STAFF REPORT
(Final Plat; Preliminary Approved 9/10/87)

CASE NUMBER: S/D 87-83 - PARCEL 104

Re: Final Plat S/D 87-83 - PARCEL 104

Re: Preliminary Plat S/D 87-83 - PARCEL 104

PARCEL 104 PRELIMINARY PLAT

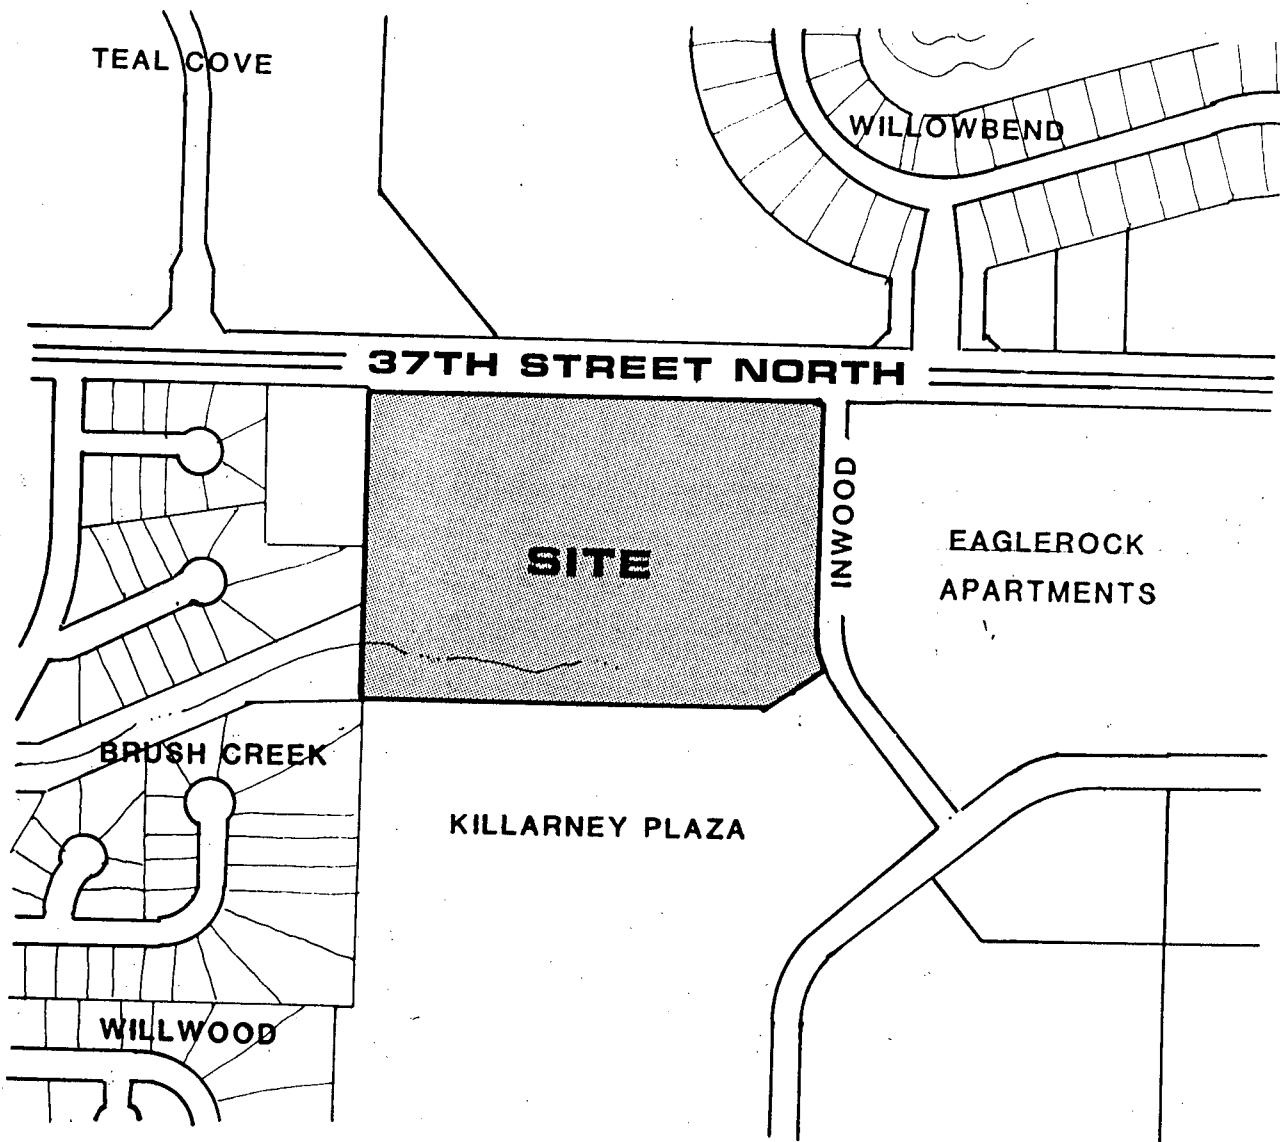
- A. The applicant shall guarantee the extension of sanitary sewer to serve the lots being platted.
- B. The applicant shall guarantee all drainage improvements required by the platting of this property.

- C. The applicant shall submit a sidewalk certificate stating that a sidewalk will be constructed on Inwood at the time of site development. (Commercial Zoning)

- D. In accordance with the Community Unit Plan provision #23, the applicant shall guarantee the construction of that portion of the required major entrance to serve Lot 3 that is within street right-of-way.

- F. The final plat shall indicate the recording information for the 50-foot Cooperative Refinery easement on this property.
- G. Any relocation, lowering or encasement of the pipeline, made necessary by this development, will not be at the expense of the City.

- H. The applicant shall provide proof, by letter from the pipeline company or by providing a copy of the pipeline easement agreement, that utilities and buildings may be located adjacent to the easement without restriction of an established setback from the easement.

- I. On the final plat, the pipeline easement on this property shall be dimensioned from lot corners.
- J. As required by the CUP, a 35-foot building setback shall be shown from the drainage easement in the southwest corner of Lot 3.

- K. The final plat tracing shall indicate the existing half-street rights-of-way for Inwood adjacent to this property.
- L. The applicant shall obtain, by separate instrument, the 130-foot wide drainage easement proposed to the south of this plat.

- M. On the final plat, the 10-foot landscape buffer shall be deleted from the face of the plat.
- N. Since existing public easements are being vacated by virtue of this plat, the plat's text shall make proper reference to K.S.A. 12-512(b).

- O. On the final plat, the plattor's text shall reference the platting of the 5-foot wall easement proposed adjacent to the west line of the plat.
- P. Prior to, or at the time of submitting the final plat, the applicant shall submit a drainage plan to City Engineering for review and approval.

- S. Requirements for a final plat (see pages 20-25, Part 4, Article 5 of the MAPC Subdivision Regulations).
- T. The representative from City Engineering should be prepared to comment on the status of the applicant's drainage concept.

- U. The provisions of the associated Community Unit Plan state, that at the time of platting, a determination shall be made regarding the need for the applicant to guarantee construction of a decel lane on 37th Street North to serve this commercially zoned property. The following amounts of development are proposed on the lots within this subdivision.

The representative from the City Engineer's office should be prepared to state if this amount and type of commercial development requires a decel lane to serve the property. Also, if a decel lane is determined to be needed, is 10 feet of additional street right-of-way needed to construct the decel lane improvement?
